\_\_\_\_\_  
In the Matter of )  
 )  
LONG ISLAND LIGHTING COMPANY )  
 )  
(Shoreham Nuclear Power Station, )  
 )  
Unit 1) )  
\_\_\_\_\_

Docket No. 50-322-OL-3  
(Emergency Planning)

DIRECT TESTIMONY OF DAVID T. HARTGEN, Ph.D., P.E., ON BEHALF OF  
THE STATE OF NEW YORK REGARDING IMMATERIALITY ISSUES

ATTACHMENT 4  
ZONE 4 NETWORK

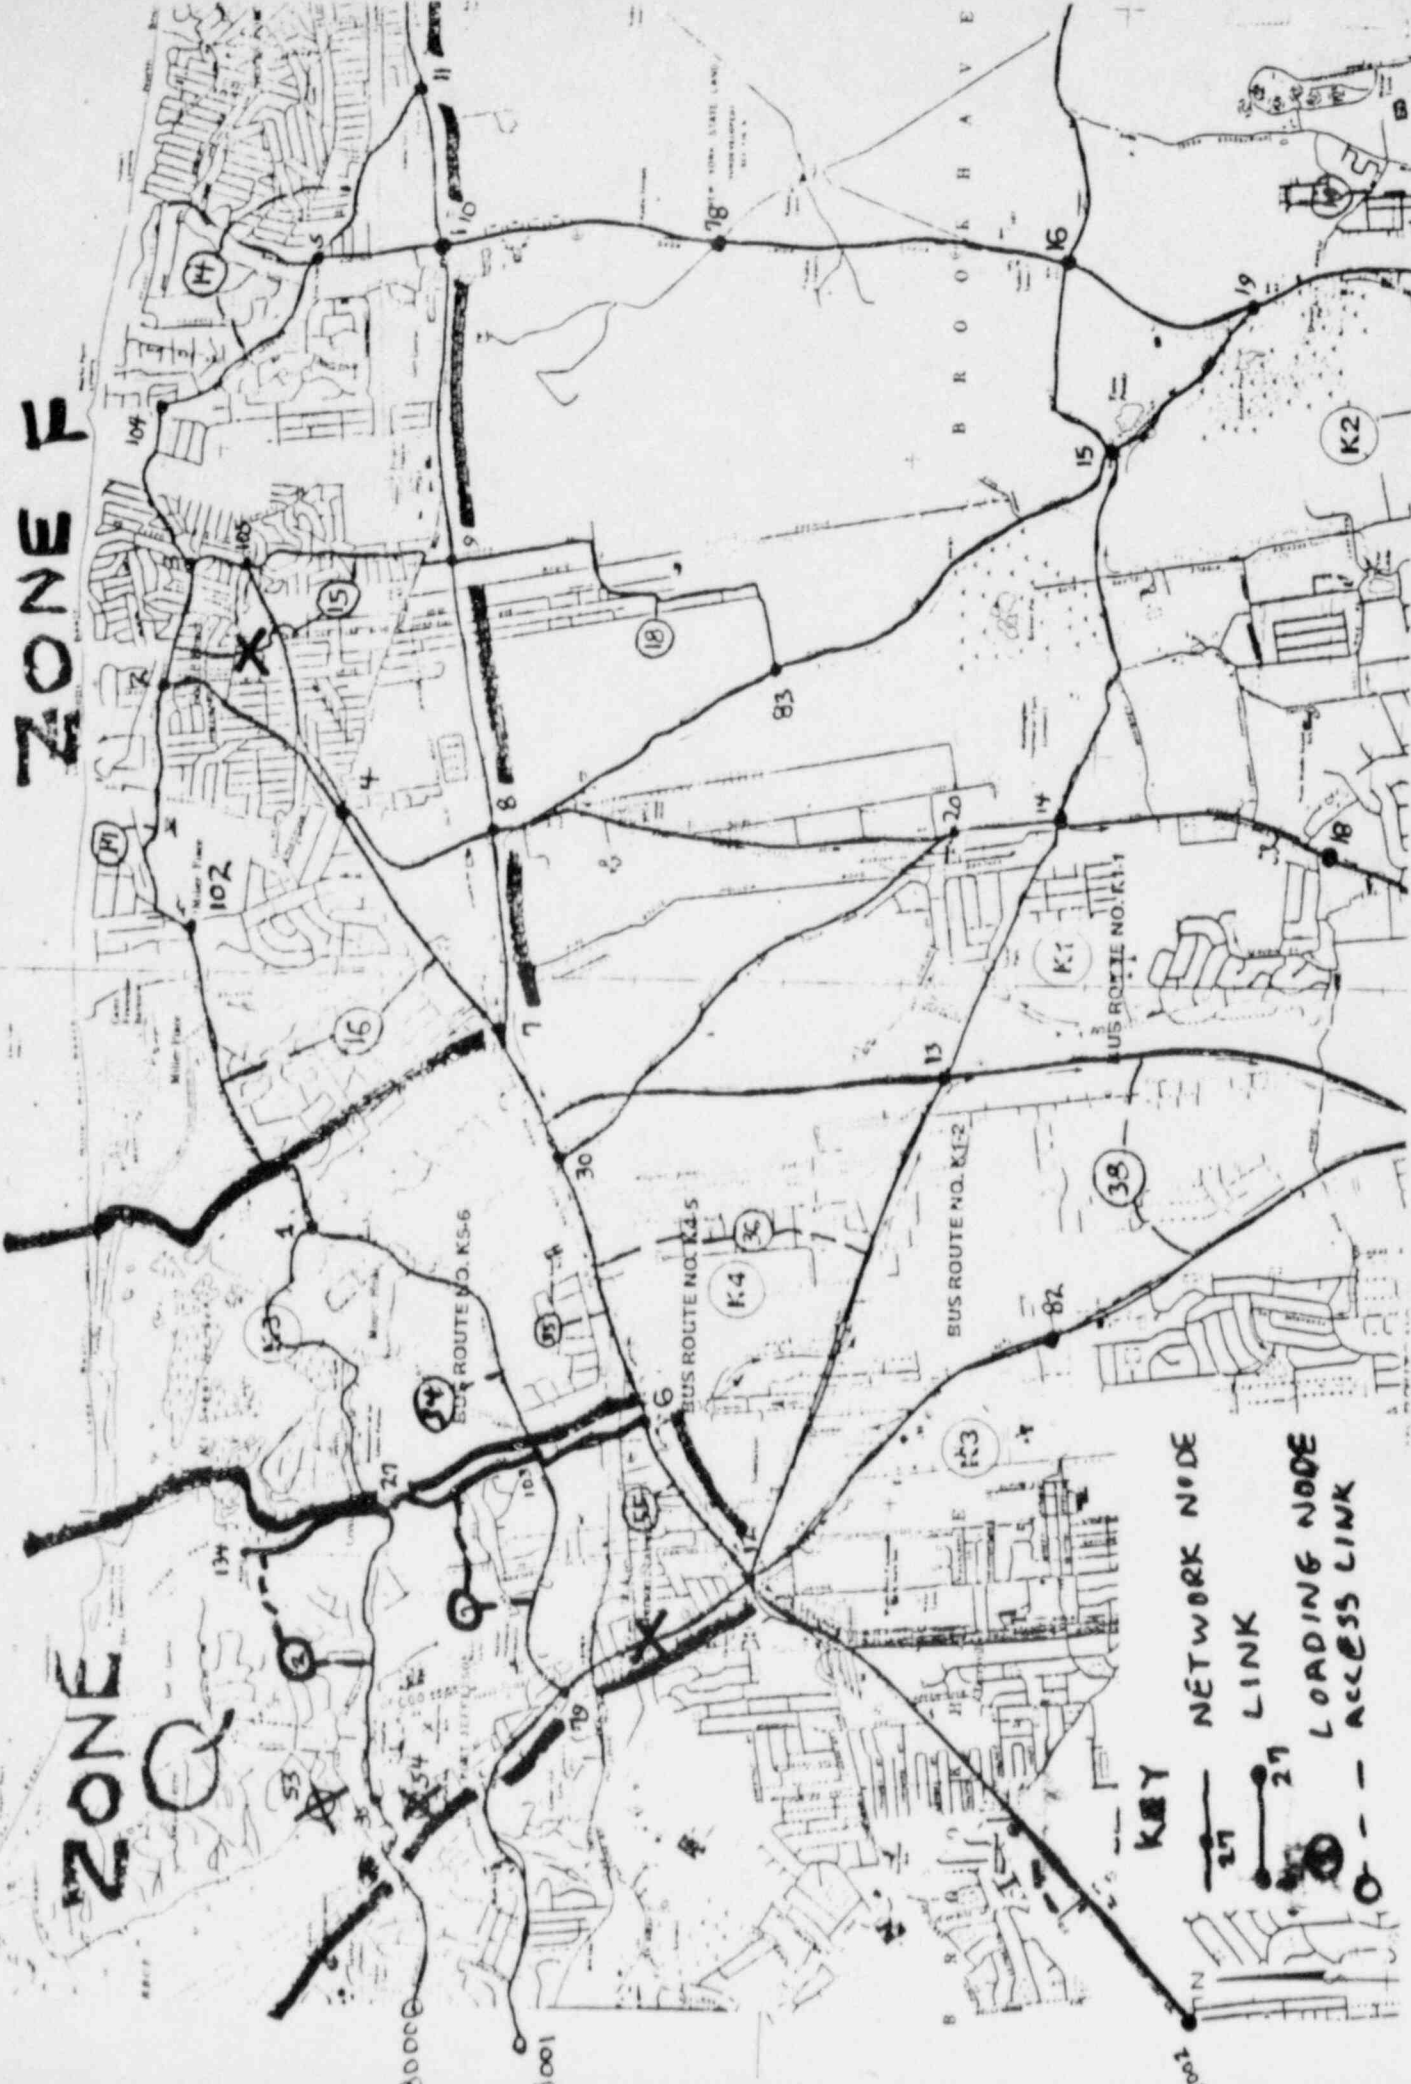
I compared the maps of the networks and the desire lines (travel patterns) shown in Rev. 3 and Rev. 5. See Attachments 2 & 3 hereto, respectively. I determined that, on the basis of a comparison of maps, Rev. 5 differs from Rev. 3 in the following ways (see Attachments 4 & 5 hereto):

2. Rev. 5 added 3 network nodes in Zone Q (134, 27, 103), which correspond to the intersections of a minor street, Crystal Brook Hollow Road, with other roads in the network.

3. Rev. 5 added 3 links in Zone Q (134-27, 27-103, 103-6) to represent Crystal Brook Hollow Road.
4. Rev. 5 created 4 other links (1-27, 27-35, 1-103, 103-79) by adding the above 3 network nodes (1-27, 27-35, 1-103, 103-79) and 4 access links<sup>5</sup>, which connect loading nodes 2 & 7 to the network.

5. Rev. 5 deleted a key roadway link (12-79) connecting Route 25A to North County Road in Zone Q.
6. Rev. 5 deleted a key access link (loading node 15 to link 2-3) located in the east part of Zone F near North Country Road.

By removing the connection between Rt. 25A and North Country Road (link 12-79) from the network, LILCO artificially and unrealistically prevents evacuation traffic from travelling northwest on Rt. 25A. In a real evacuation, if congestion were to occur on Rt. 25A, evacuees would try other paths; the deletion of this link prevents them from doing so even in an uncontrolled evacuation.

Moreover, by deleting link 12-79, the model forces some residents of Zone Q to travel in a circuitous route (node 7 to node 103 to node 6 to node 12 to node 8002) when proceeding from the vicinity of node 7 to the vicinity of destination node 8002, rather than to travel on a more direct path along link 12-79.

A. Yes. The street in question is a portion of North Country Road (that becomes lower Rocky Point Road) between Shore Road and Woodhull Landing Road (links 102-1 and 2-102 on Attachment 4 hereto). This street was converted to one-way (2 lanes westbound) in the "controlled" tests, but left as two-way (1 lane westbound) in the "uncontrolled" tests.

A. Yes. I reviewed, Rt. 25A between Echo Avenue & Mt. Sinai-Coram Road (link 7-30 in Attachment 4 hereto). LILCO gave this section two lanes westbound in controlled assignments, but one lane westbound in uncontrolled assignments.

DESIRE LINES ATTACHMENT  
5  
**ZONE F**

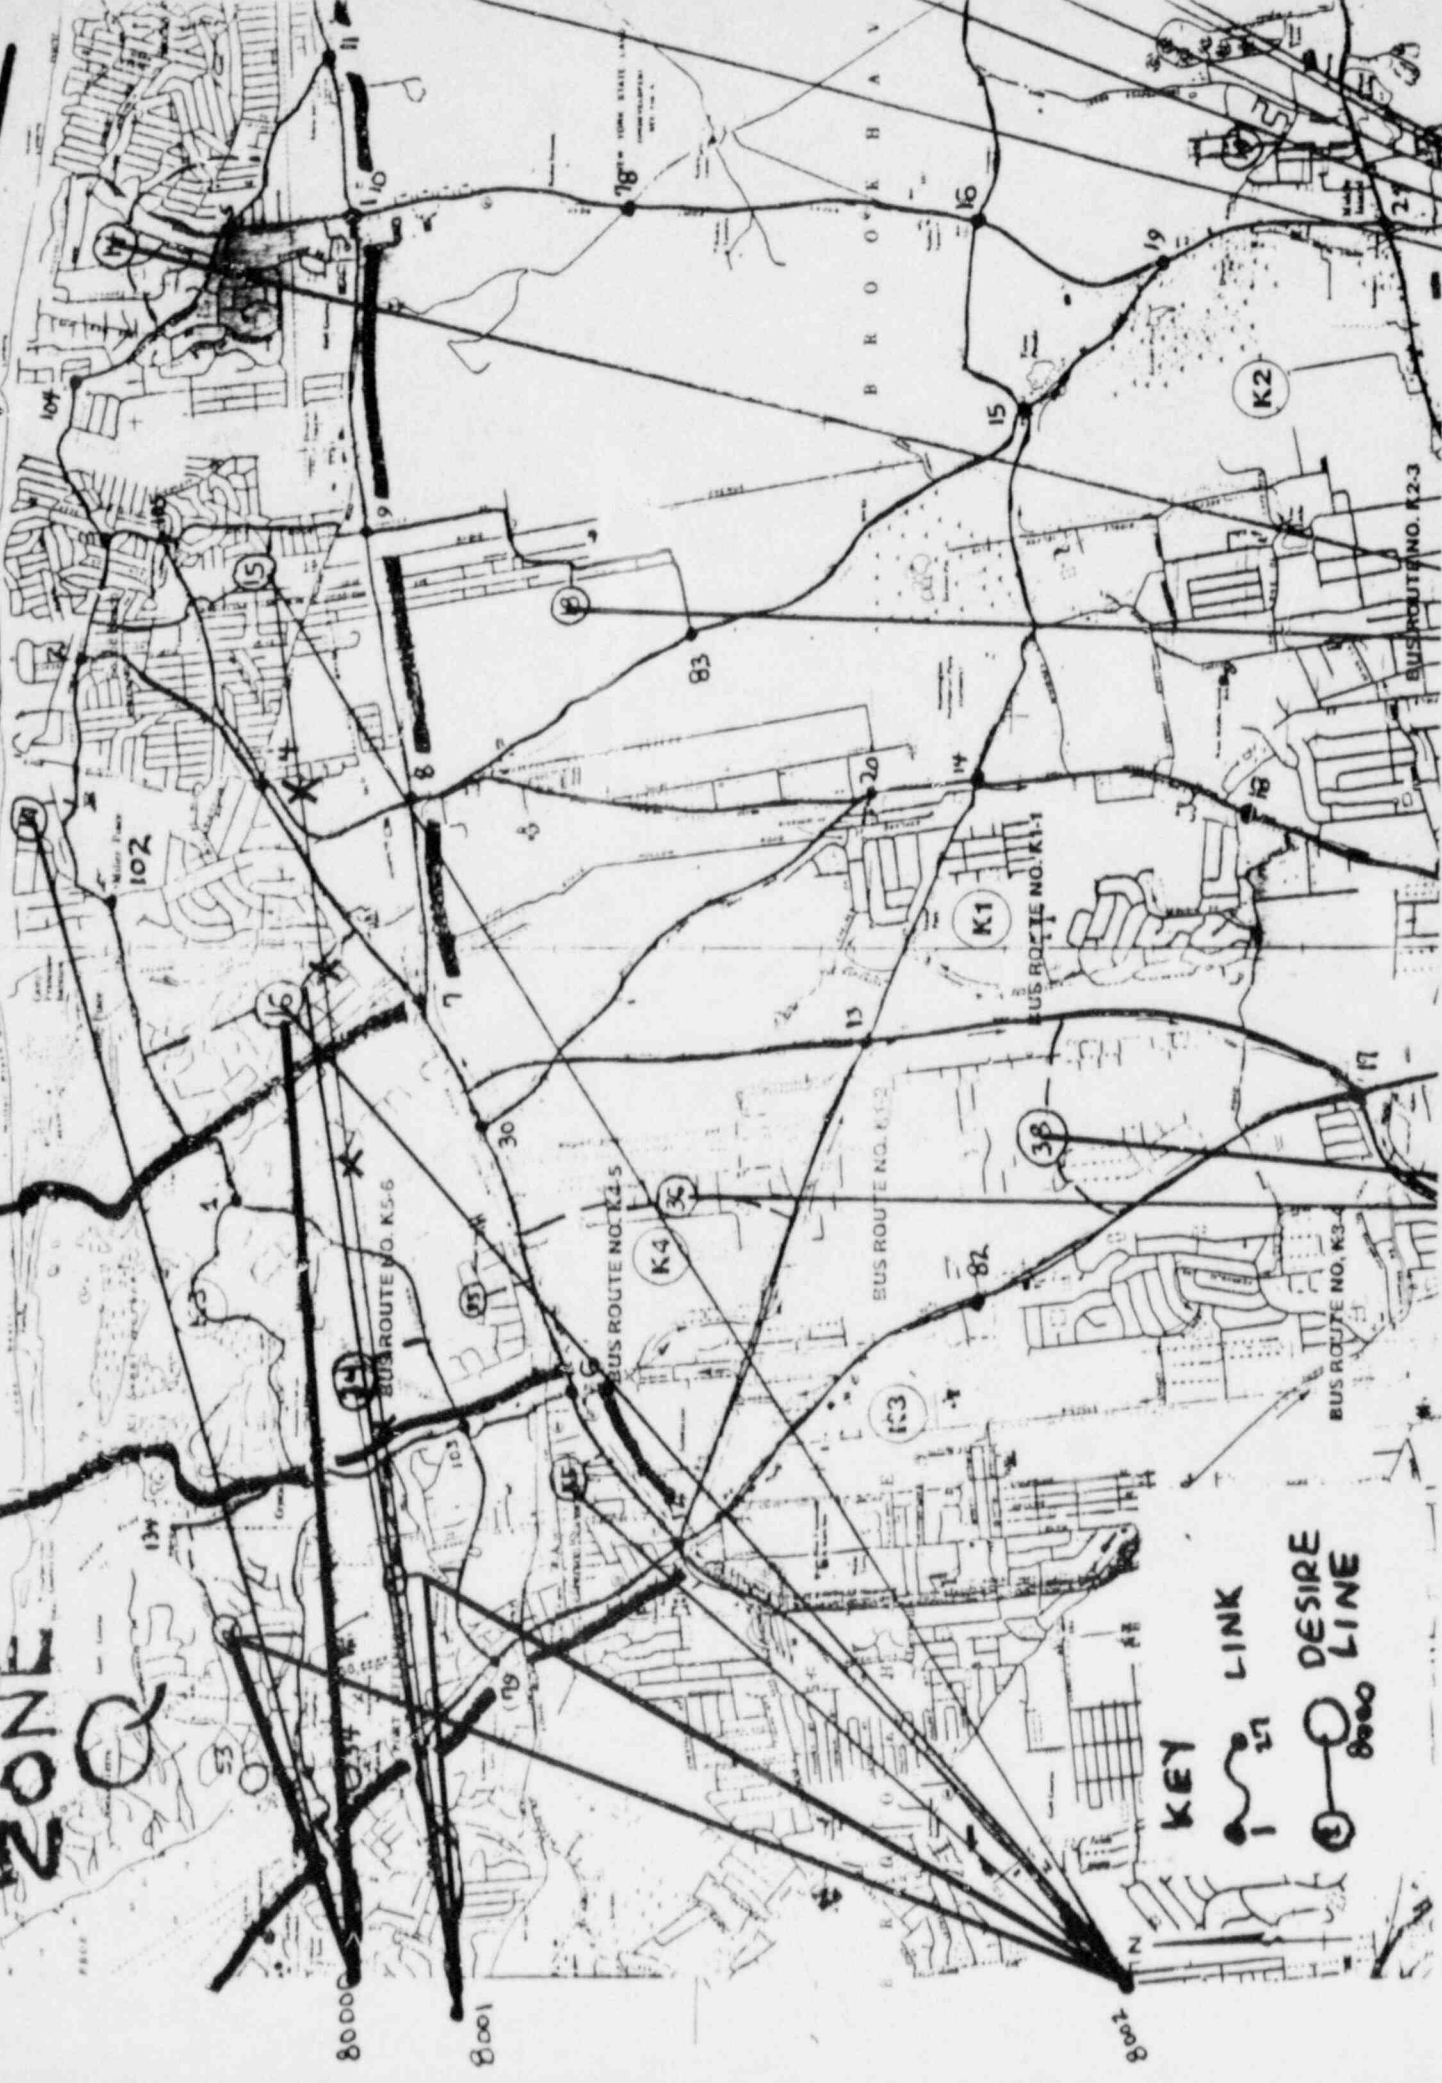
7. Rev. 5 deleted a key desire line (15-8001) from the middle portion of Zone F to Port Jefferson.
8. Rev. 5 added a desire line (load node 16 to destination node 8000) connecting the far west portion of Zone F to Port Jefferson.

9. Rev. 5 added 4 desire lines (2-8000, 2-8001, 7-8001, 7-8002) connecting the new loading nodes in Zone Q to existing destination nodes.
10. Rev. 5 deleted 2 nodes (53 and 54) in Zone Q.

Further, the deletion of the 15-8001 desire line which ran from Zone F to the west (see Attachment 5 hereto), along with the deletion of the access link from loading node 15 to link 2-3 (see Attachment 4 hereto), constrains residents from the middle of Zone F (loading node 15) to evacuate to the south and southwest, rather than to the west along North Country Road or Old Post Road. North Country Road or Old Post Road would be most preferable to evacuees in an uncontrolled evacuation because those roads intersect the area, whereas Rt. 25A does not. Their normal behavior (i.e., heading west) would thus be thwarted. Accordingly, the evacuation tested by LILCO is not "uncontrolled" at all.

ATTACHMENT  
6

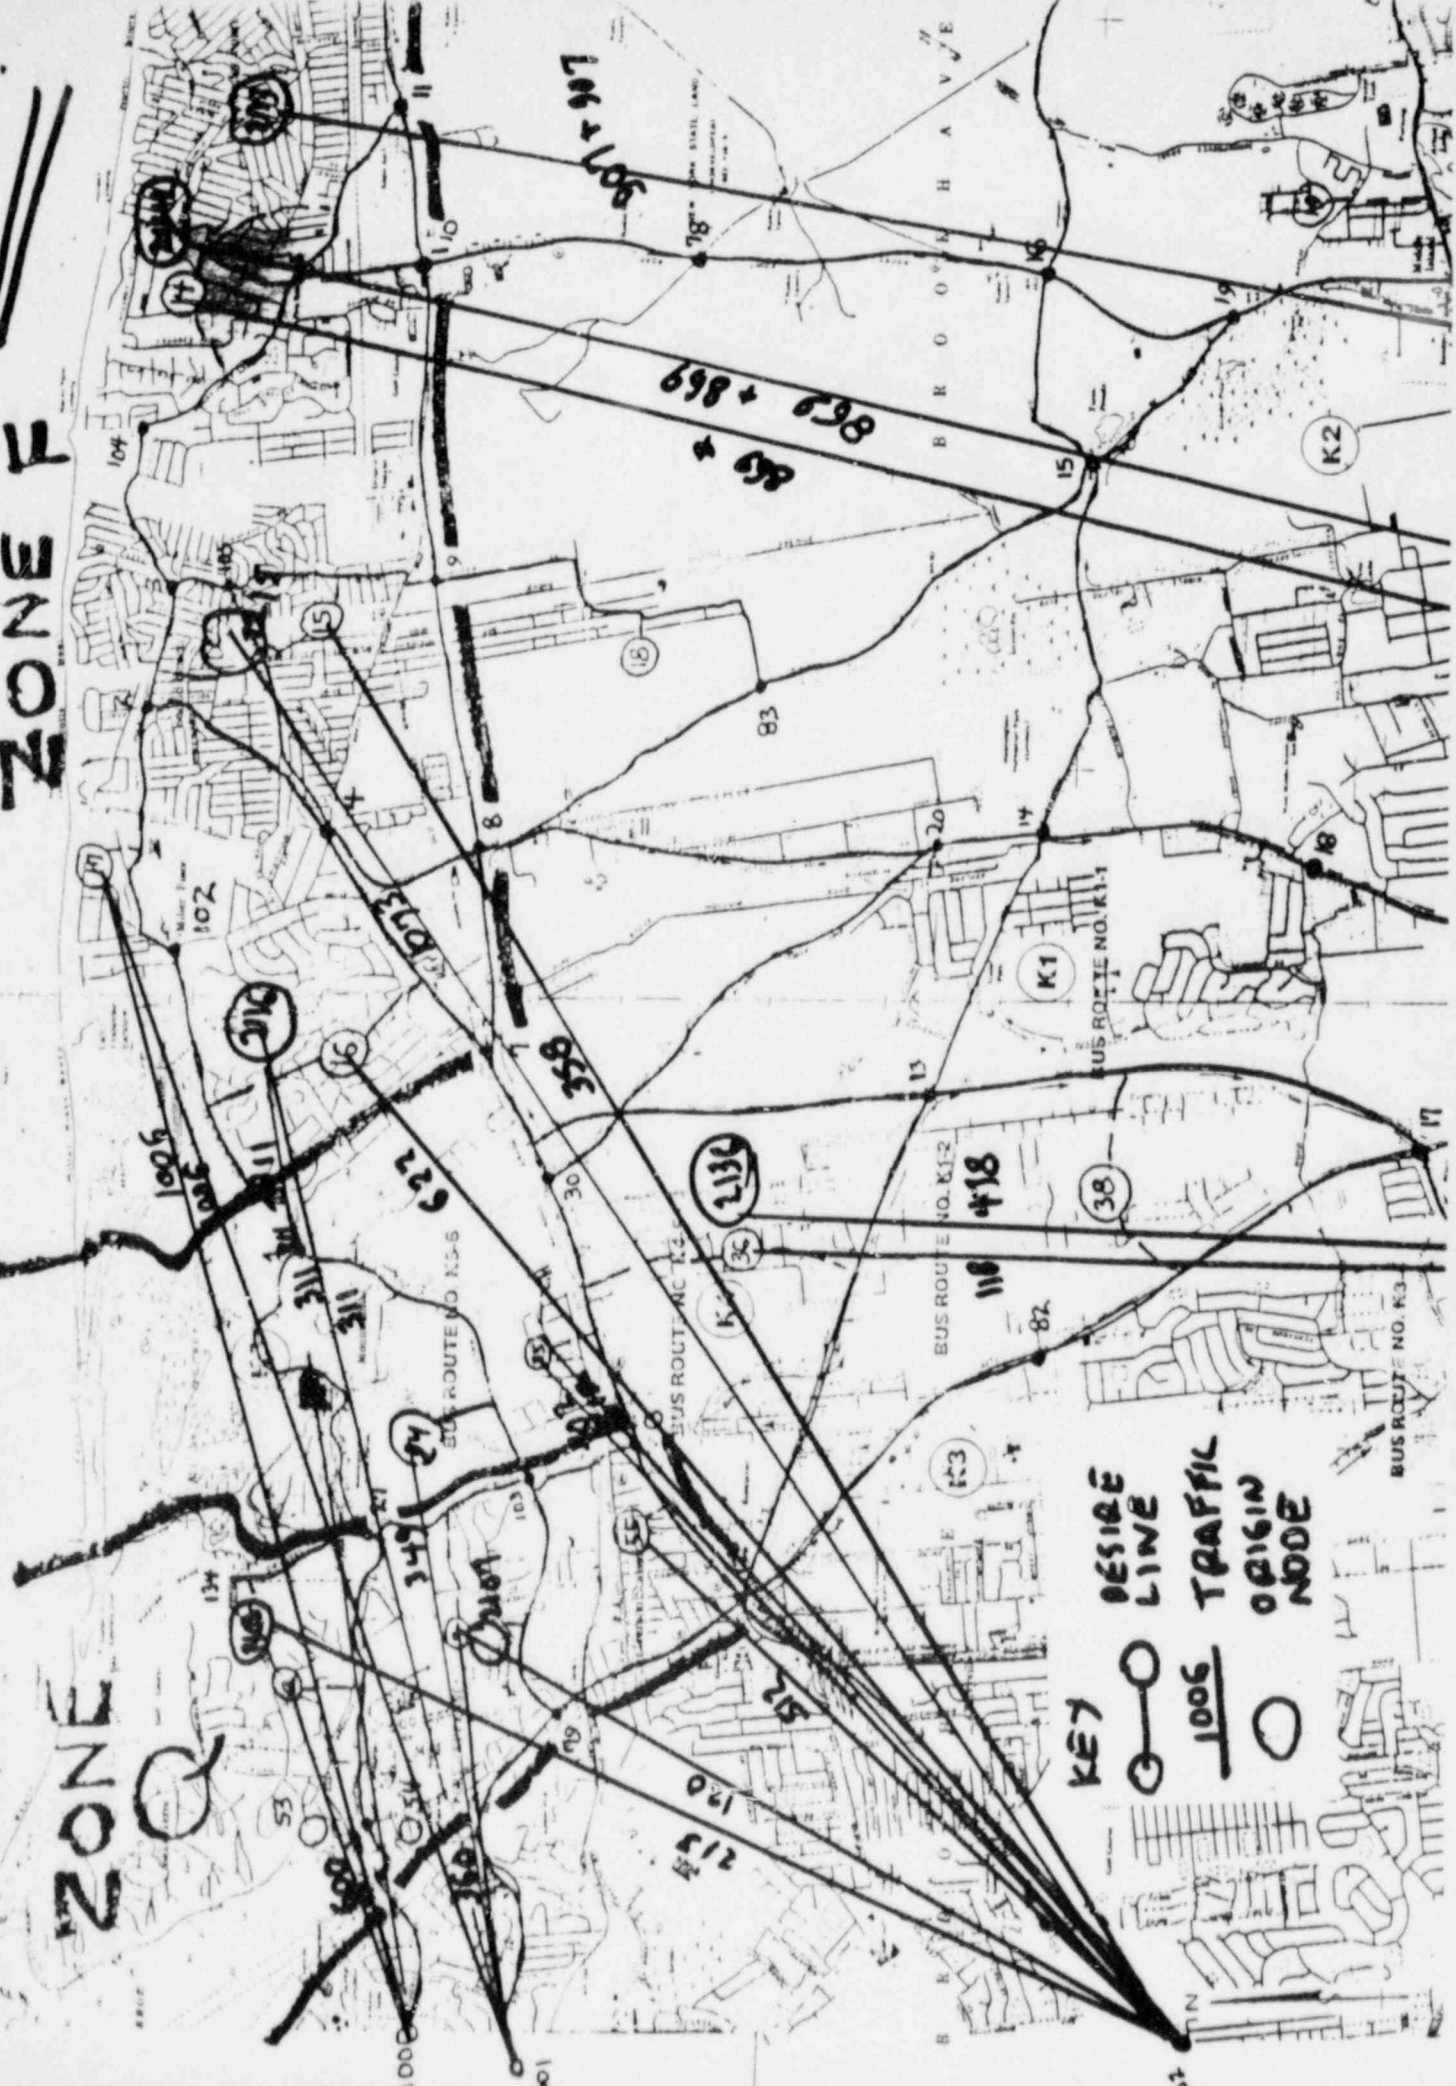
- o Partitioning of Zone Q's loading nodes into 5 nodes (2002, 2102, 2007, 2107, 2055).
- o Partitioning of Zone F's loading nodes into several sub-nodes (2016, 2116, 2015, 2215, 2014, 2114, 2017, 2113).
- o Adding numerous desire lines connecting these sub-zones to exit destinations.
- o Converted a section of street to one-way flow (two lanes westbound) specifically, links 2-102 and 102-1 in Zone F.

- c Made two lanes available for westbound movement on Rt. 25A between Echo and Mt. Sinai-Coram Road (link 7-30).

These patterns are shown in Attachments 6 and 7 hereto, respectively. Here, I must emphasize that my findings on the computer printouts are tentative because they were received at a late date from LILCO and because it was not possible, to depose LILCO's traffic expert on the meaning and interpretation of some of the printouts. If, as the printouts appear to indicate, the above changes have been made, the evacuation has been severely constrained. In particular, according to the model, it would not be possible in either of the above controlled or uncontrolled scenarios for residents of the middle portion of Zone F to evacuate through Port Jefferson. That however, is what those evacuees in either of the above controlled or uncontrolled scenarios are likely to try to do because the edge of the EPZ is closer by heading directly west and westbound roads intersect the middle portion of Zone F.
